Proposal for collective amendments to Regulation Nos. 44 and 129

I. Proposal for Supplement 10 to the 04 series of amendments to Regulation No. 44 (Child restraint systems)

II. Proposal for Supplement 05 to the 00 series of amendments to Regulation No. 129 (Enhanced Child restraint systems)

Figure 1

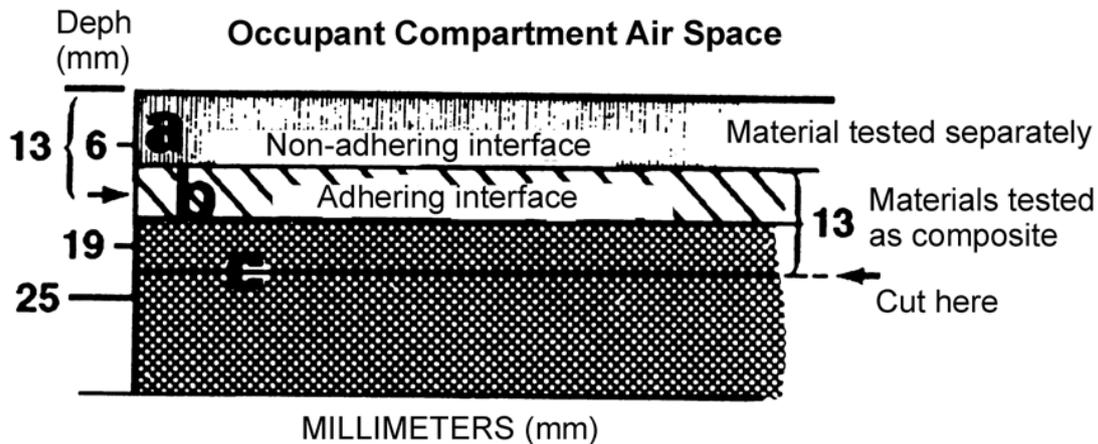
1. Definitions
"Occupant compartment air space" means the space within the occupant compartment that normally contains refreshable air.
2. Material selection (see Figure 1 below)
 - 2.1. Any portion of a single or composite material which is within 13 mm of the occupant compartment air space shall meet the requirements in Paragraph 6.1.6.
 - 2.1.1 Any material that does not adhere to other material(s) at every point of contact shall meet the requirements of Paragraph 6.1.6. when tested separately
 - 2.1.2 Any material that adheres to other materials at every point of contact shall meet the requirements of Paragraph 6.1.6. when tested as a composite with the other material(s).

Material A has a non-adhering interface with material B and is tested separately. Part of material B is within 13 mm of the occupant compartment air space, and materials B and C adhere at every point of contact; therefore, B and C are tested as a composite. The cut is in material C as shown, to make a specimen 13 mm thick.

Figure 2
All dimensions in millimeters (mm)

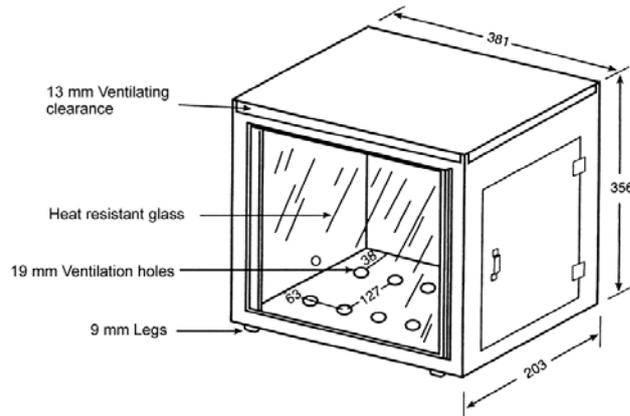
- 3.1 The test is conducted in a metal cabinet for protecting the test specimens from drafts. The interior of the cabinet is 381 mm long, 203 mm deep, and 356 mm high. It has a glass observation window in the front, a closable opening to permit insertion of the specimen holder, and a hole to accommodate tubing for a gas burner. For ventilation, it has a 13 mm clearance space around the top of the cabinet, ten holes in the base of the cabinet, each hole 19 mm in diameter and legs to elevate the bottom of the cabinet by 10 mm, all located as shown in Figure 2.

Figure 1

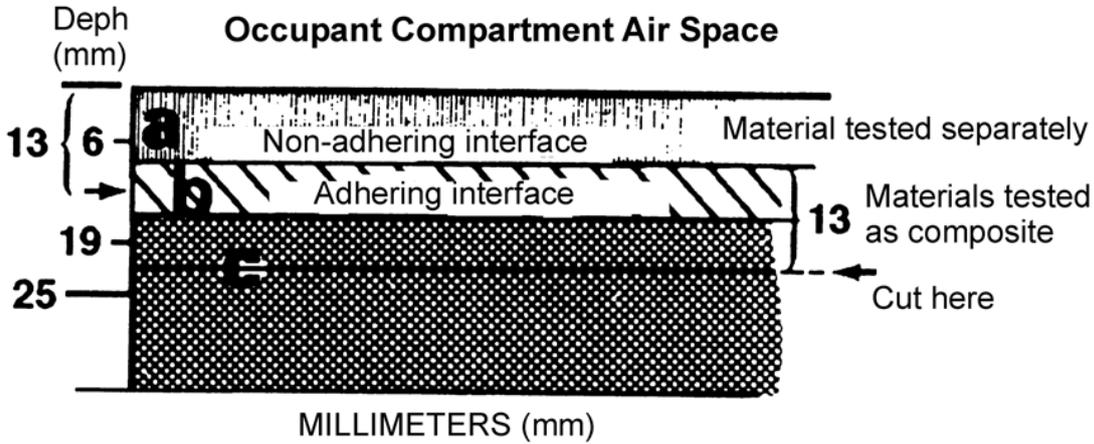
1. Definitions
"Occupant compartment air space" means the space within the occupant compartment that normally contains refreshable air.
2. Material selection (see Figure 1 below)
 - 2.1. Any portion of a single or composite material which is within 13 mm of the occupant compartment air space shall meet the requirements in Paragraph 6.3.1.2.

Material A has a non-adhering interface with material B and is tested separately. Part of material B is within 13 mm of the occupant compartment air space, and materials B and C adhere at every point of contact; therefore, B and C are tested as a composite. The cut is in material C as shown, to make a specimen 13 mm thick.

Figure 2
All dimensions in millimeters (mm)

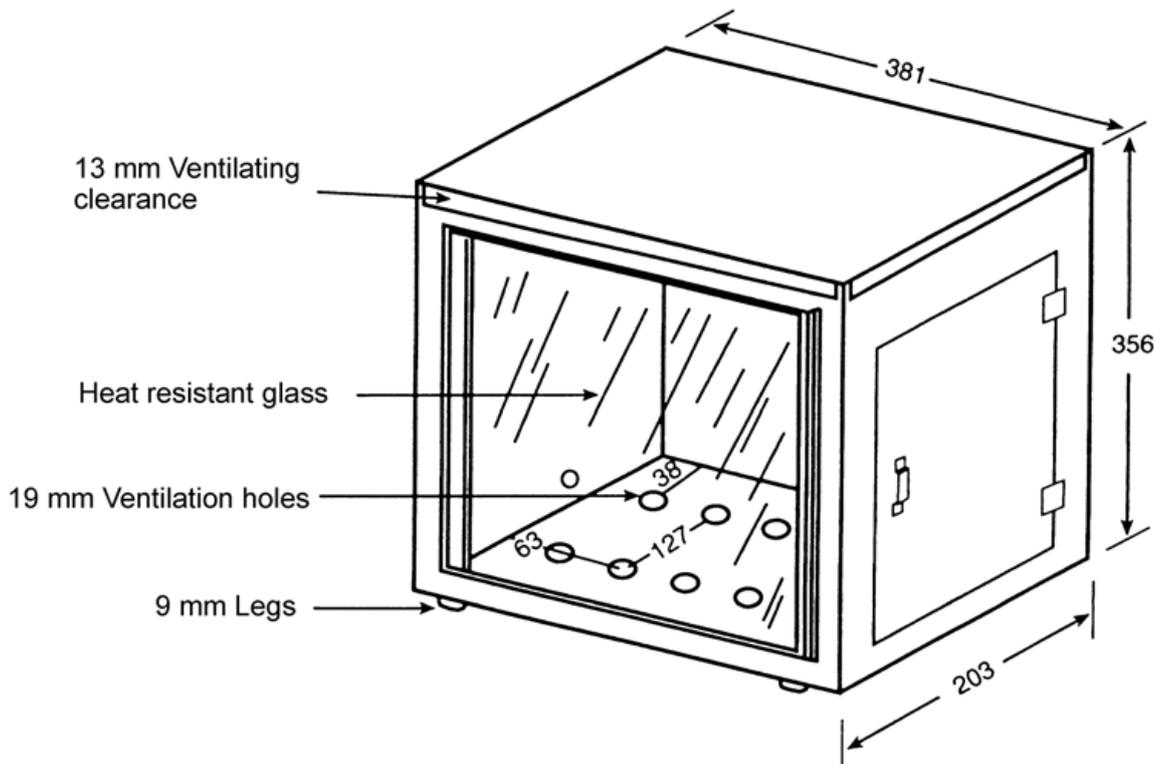
- 3.1 The test is conducted in a metal cabinet for protecting the test specimens from drafts. The interior of the cabinet is 381 mm long, 203 mm deep, and 356 mm high. It has a glass observation window in the front, a closable opening to permit insertion of the specimen holder, and a hole to accommodate tubing for a gas burner. For ventilation, it has a 13 mm clearance space around the top of the cabinet, ten holes in the base of the cabinet, each hole 19 mm in diameter and legs to elevate the bottom of the cabinet by 10 mm, all located as shown in Figure 2.
